Re: Quincy Square Park

Response to Council Order # 96 of September 11, 1995
Regarding Quincy Square

Re: Quincy Square Park (THC #95010.01)
Relocated War Memorial

SUBJECT: Report on Recent Public Review of the Quincy Square Enhancement Proposal

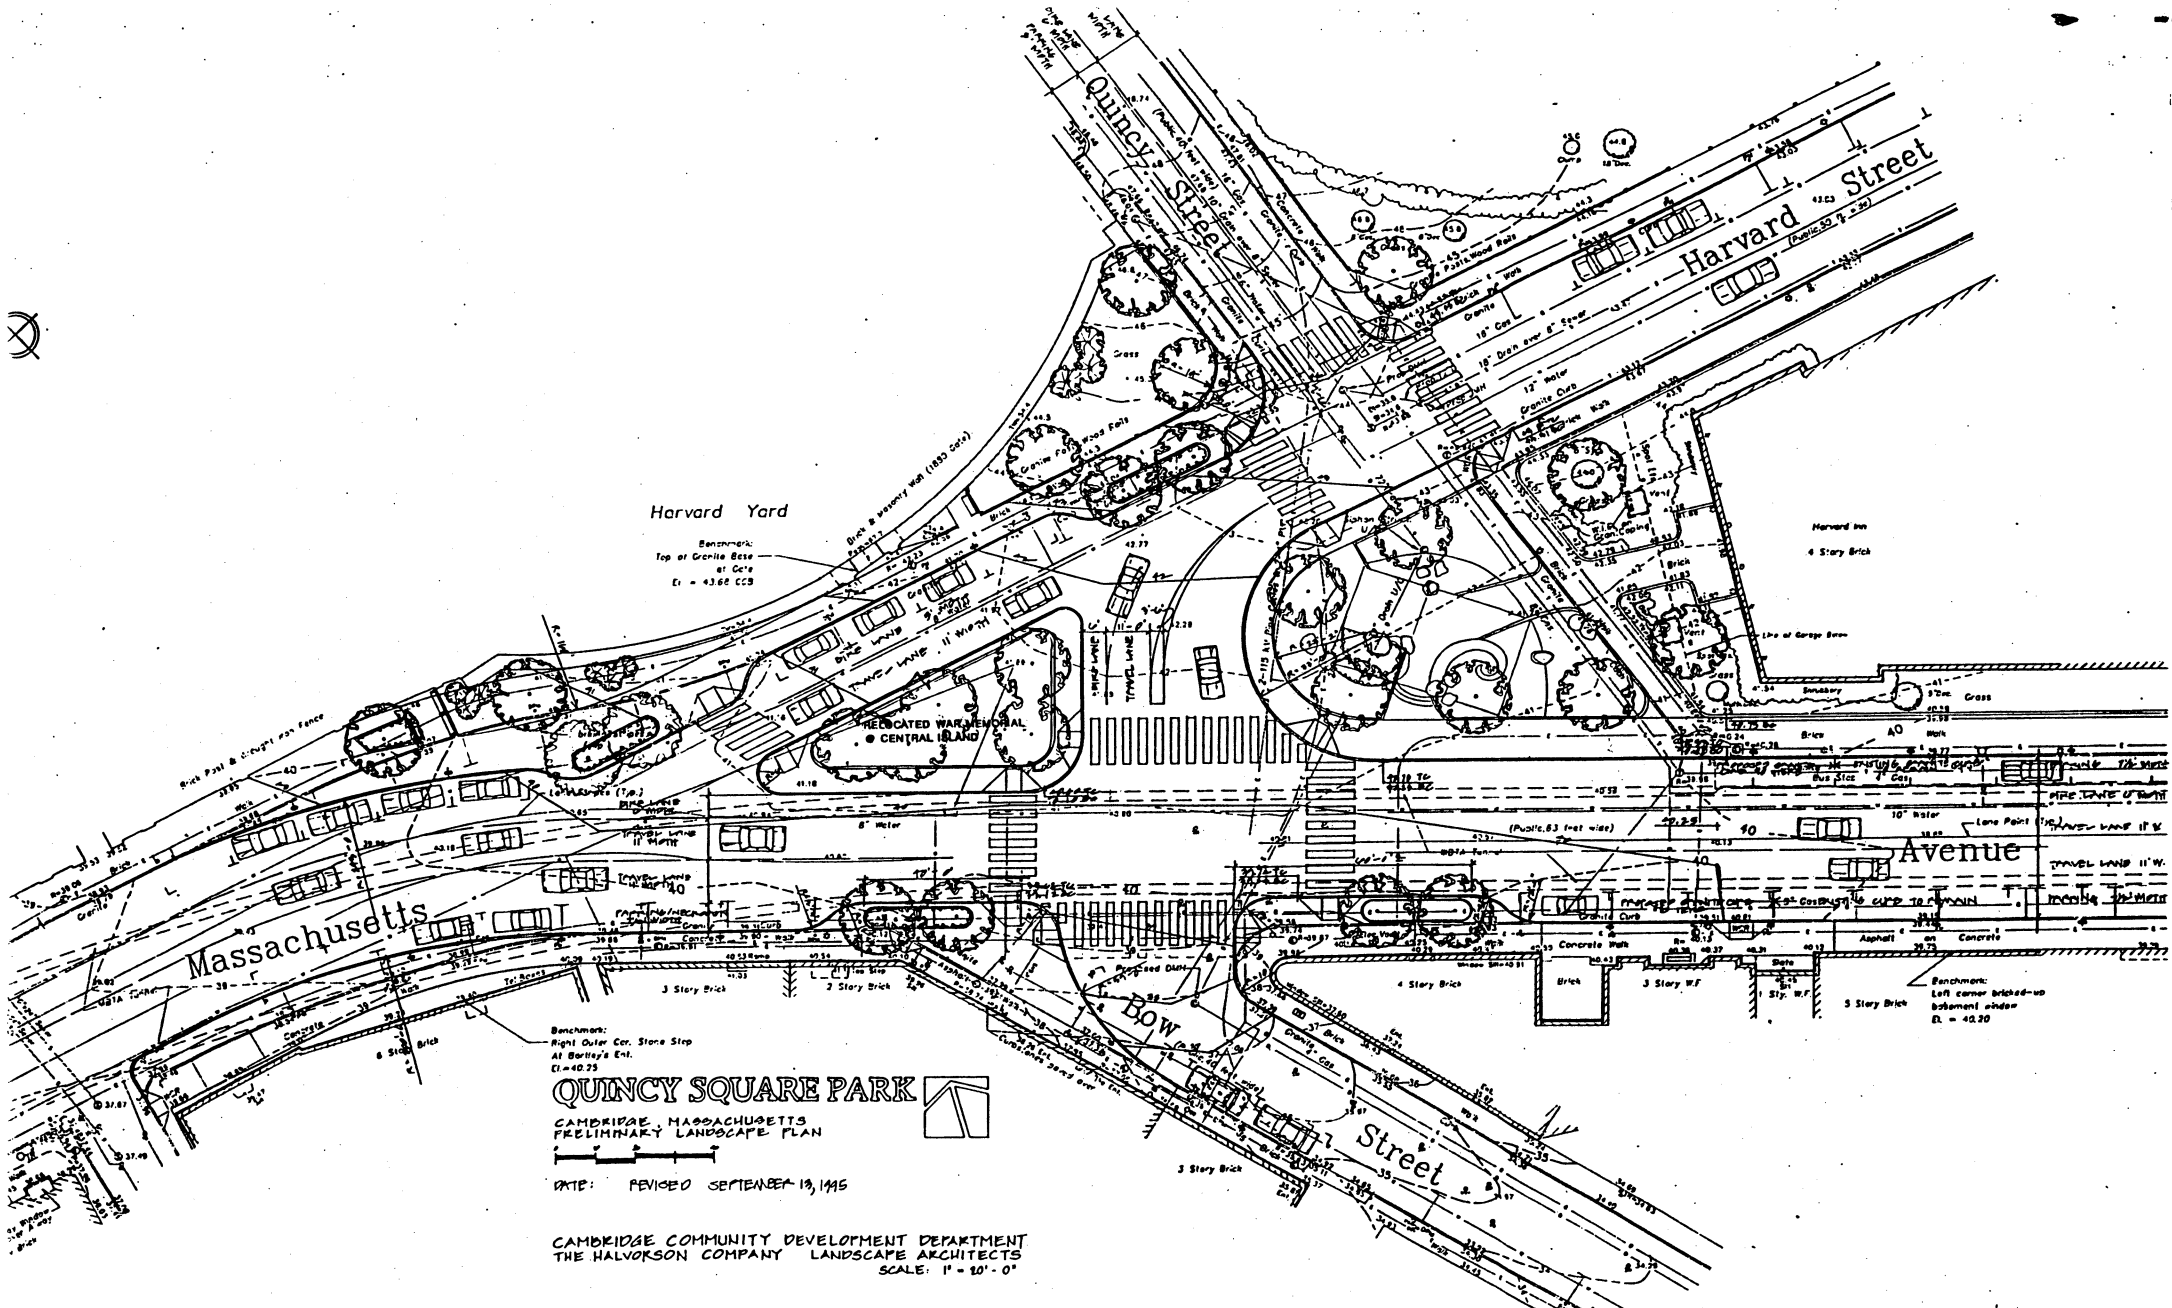
It has been our intention all along to place this stone memorial in a significant location within the new park. We feel it would be very appropriate to locate it at the proposed triangular open space defined by the convergence of Massachusetts Avenue and Harvard Street.

This proposed location for the memorial is close to its original location at the raised brick island at Quincy Square. We feel the stone memorial would not be as prominent if it were located within the peninsula space adjacent to the Inn. There are a number of other stones which are part of the sculpture and landscape there which might compete with and obscure the war memorial.

The City of Cambridge Department of Public Works is currently storing the monument in the Cambridge Cemetery. As part of the park construction contract, we intend to have the contractor clean and reset this monument in its new location in Quincy Square.
